# UNITED STATES PATENT AND TRADEMARK OFFICE

10/549,291

<b>Office Action Summary</b>	<b>Application No.</b> 10/549,291	<b>Applicant(s)</b> IWANAGA ET AL.	
	<b>Examiner</b> John Lin	<b>Art Unit</b> 2815

## DETAILED ACTION

**FIG. 10A**

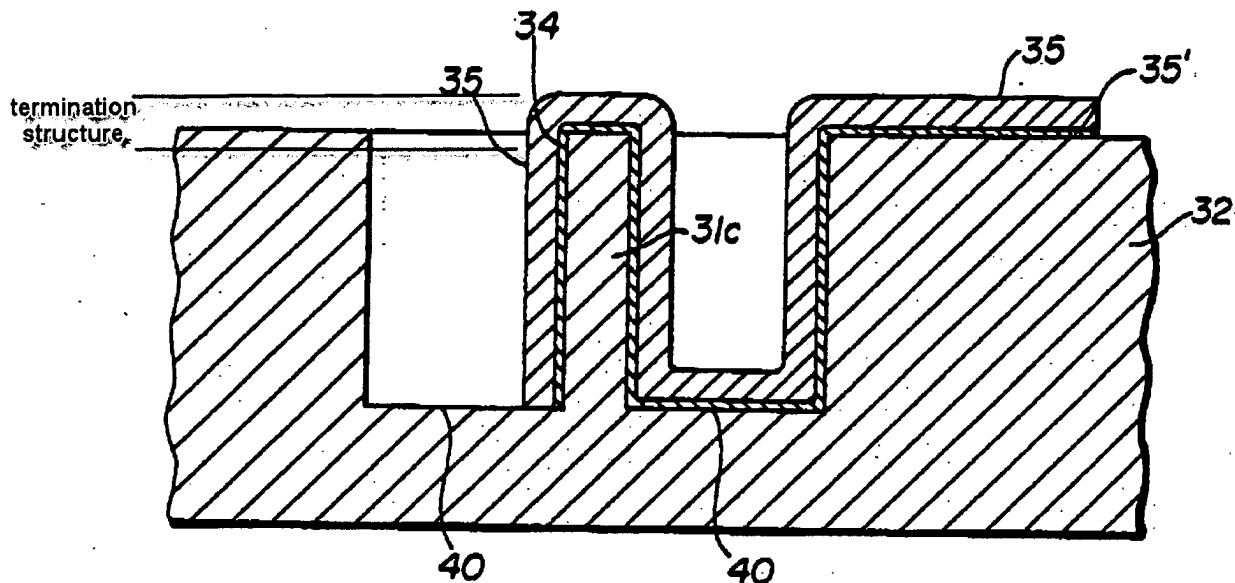
**Claim 1:** Shirasaki teaches a semiconductor device (Figs. 10 and 10A) comprising:

a semiconductor substrate (32) in which a trench (30) is formed;

a source region (31a) and a drain region (31b), each of which is buried in the trench and contains an impurity of the same conductive type;

a semiconductor FIN (31c) buried in the trench and provided between the source region and the drain region;

a gate insulating film (34) provided on a side surface of the semiconductor FIN as well as an upper surface of the semiconductor FIN; and

a gate electrode (35) having in the trench a termination structure (see Fig. 10A below) extending from the upper surface of the semiconductor FIN toward a bottom of the trench along both sides of the semiconductor FIN and formed on the gate insulating film (column 7, lines 35-67).

Examiner notes that in Fig. 10A above, Shiradaki discloses a termination structure, the termination structure extends from the upper surface of the semiconductor FIN toward a bottom of the trench along both sides of the semiconductor FIN.
